**MVSC-220/260/300/460 and MVSN-220/300 Series  
Rear Cover Exterior and Screw Change Notification**

MVSC-220/260/300/460 and MVSN-220/300 Series Solenoid Valve

Rear cover screw Change :

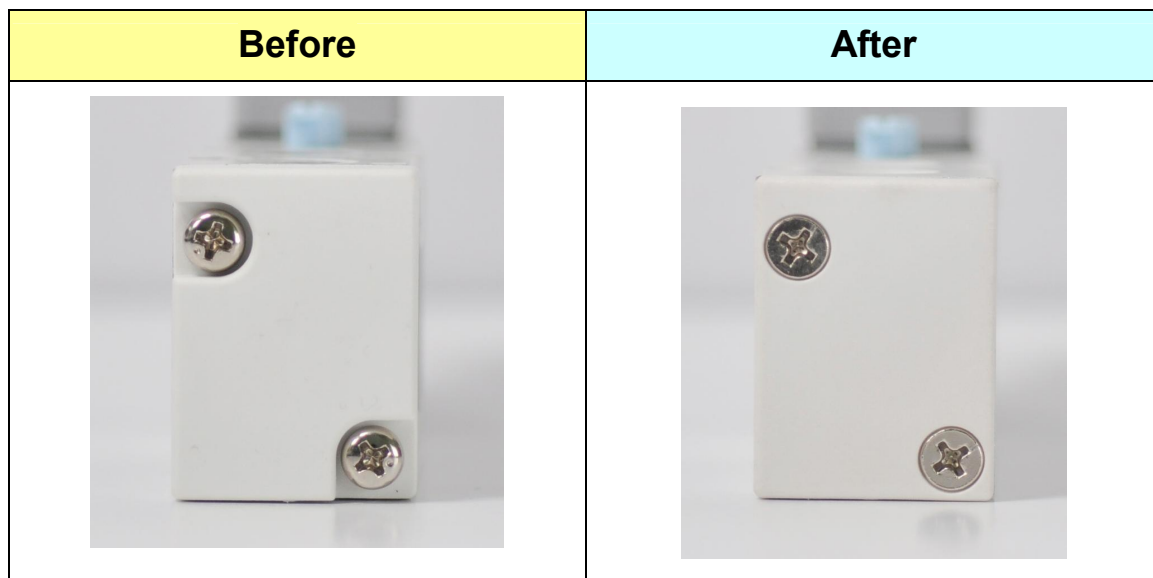
Model	Before	After
<b>MVSC-220</b>	M3x0.5x8L	M3x0.5x10L
<b>MVSN-220</b>		
<b>MVSC-260</b>	M4x0.7x10L	M4x0.7x12L (Screw Headφ7)
<b>MVSC-300</b>		
<b>MVSC-460</b>		
<b>MVSN-300</b>

Rear cover exterior change :

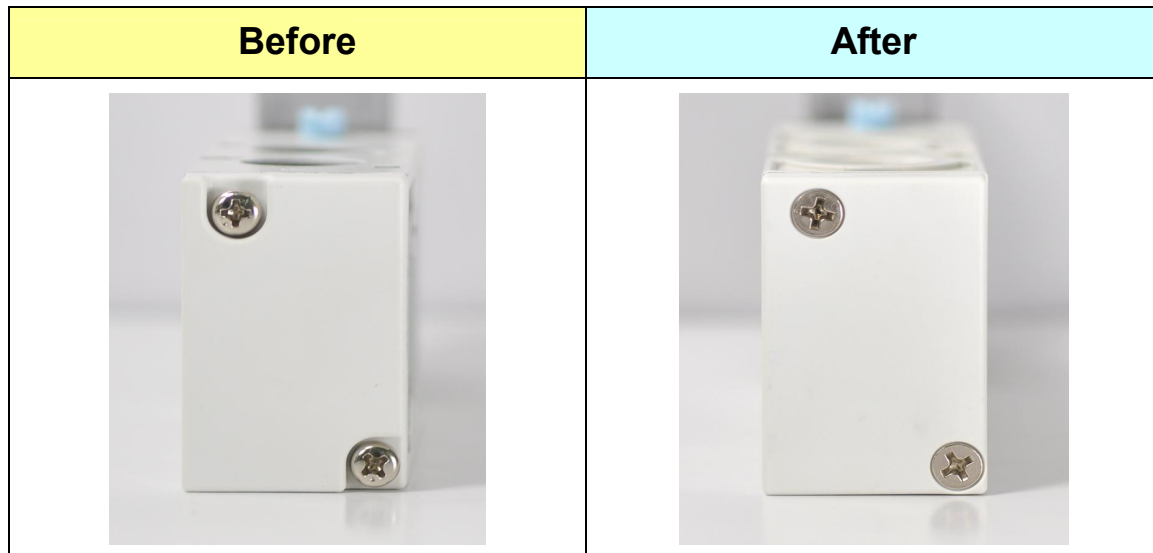
A.MVSC-220、MVSN-220 Series : Example: MVSC-220-4E1

Before	After

### B. MVSC-260 Series : Example: MVSC-260-4E1

### C. MVSC-300、MVSN-300、MVSC-460 Series : Example: MVSC-300-4E1
